Interdisciplinary Environmental Clinic

September 3, 2015

Re: 2010 1-Hour Sulfur Dioxide Standard, Proposed Options for Area Boundary
Recommendations, July 2016 Designations

Figure 1. Augusta SO₂ monitors in relation to DNR's modeled peak concentration areas.

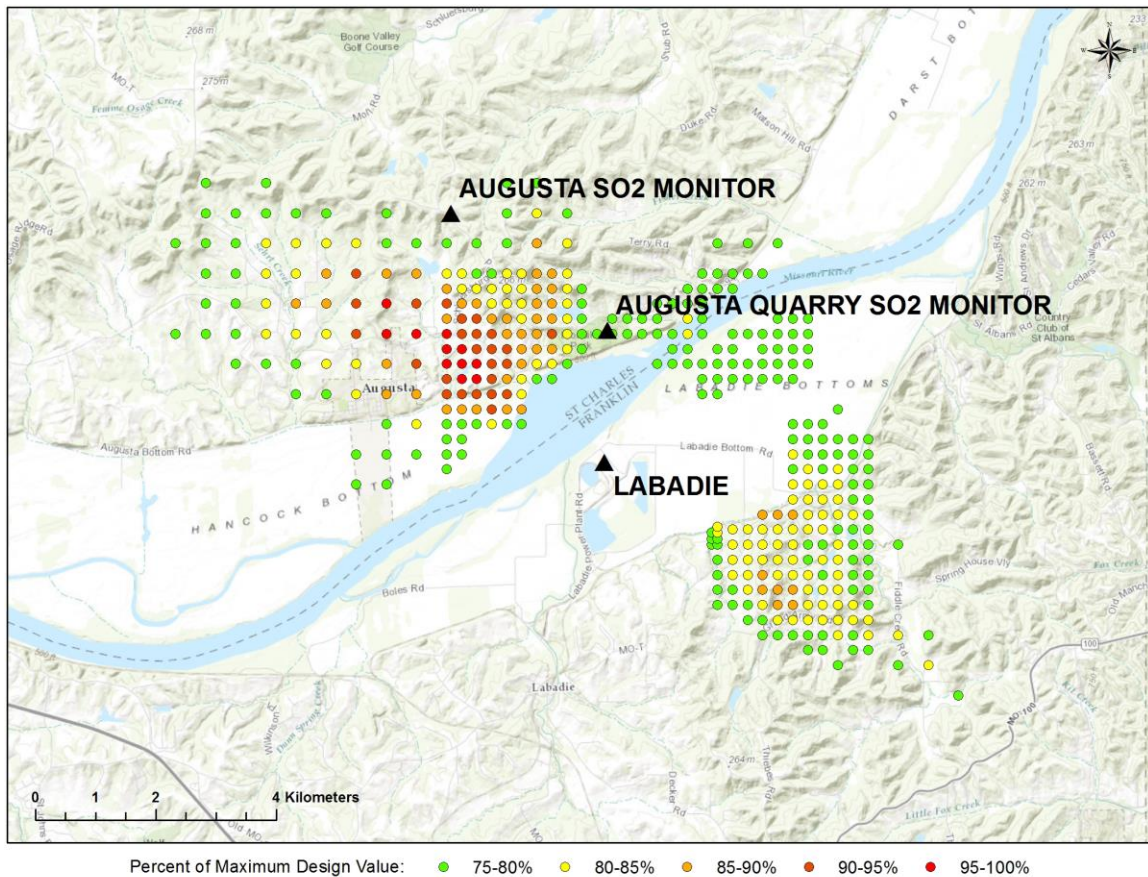
Second, monitoring data from the long-inactive Augusta and Augusta Quarry SO₂ monitors similarly fail to undermine the nonattainment designation required by DNR's modeling. There is no indication that either of those monitors was sited in areas of expected peak concentrations caused by the Labadie plant's emissions. To the contrary, DNR's modeling indicates that they were not sited in areas of expected peak concentrations associated with Labadie's emissions. This is shown in Figure 1, below.

Furthermore, the data from the Augusta monitors reveal high 1-hour SO₂ concentrations, with consistent violations of the NAAQS. The Augusta monitor operated from July 1, 1987 until December 19, 1994. The design values for every three-year period during the monitor's operation were well above the 1-hour SO₂ NAAQS – ranging from 259 ppb for 1987-1989 to 114 ppb for 1992-1994.¹⁸ The Augusta Quarry site operated for three full years (1995-1997) and portions of two additional years (1994 and 1998). The design value for the only complete three-year period was 78 ppb, exceeding the 1-hour SO₂ NAAQS. The fourth-highest one-hour readings during two of the three complete data years were well above the 1-hour SO₂ NAAQS (86 ppb in 1995 and 80 ppb in 1997).¹⁹

Figure 2. Alternative nonattainment area boundary based on Spirit of St. Louis Airport meteorological data.

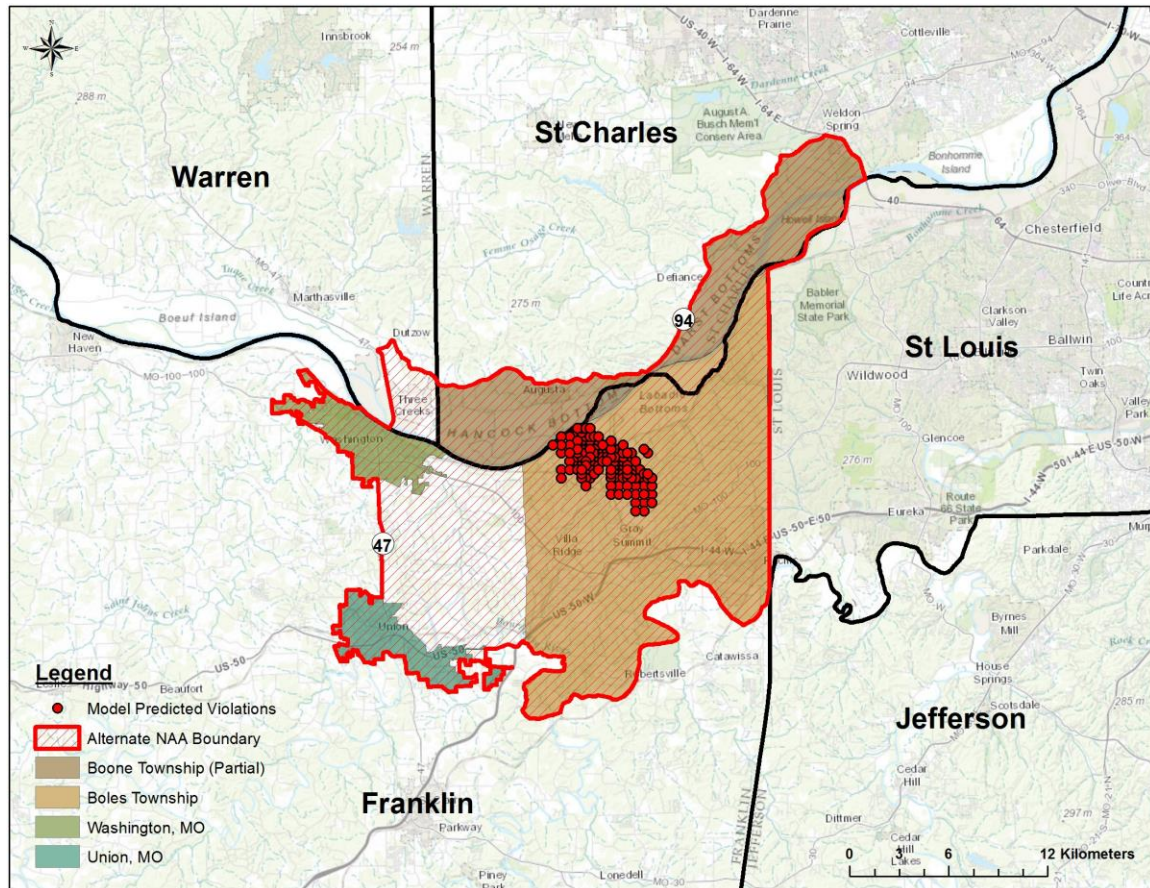
Alternatively, DNR should consider modifying the proposed boundaries of the nonattainment area to encompass a larger portion of northeast Franklin County, which DNR's modeling suggests encompasses most if not all modeled violations when potentially more representative meteorological data from the Spirit of St. Louis Airport in Chesterfield is used.³⁰ With Spirit of St. Louis Airport meteorological data, the locus of modeled violations shifts to the south and southwest of the plant. A more appropriate nonattainment area boundary based on these modeled violations would encompass Boles Township, a small portion of Boone Township (south of

Missouri Highway 94), and the area west of Boles Township bounded by Missouri Route 47 and the municipal boundaries of Washington and Union, Missouri. This is shown in Figure 2, below.
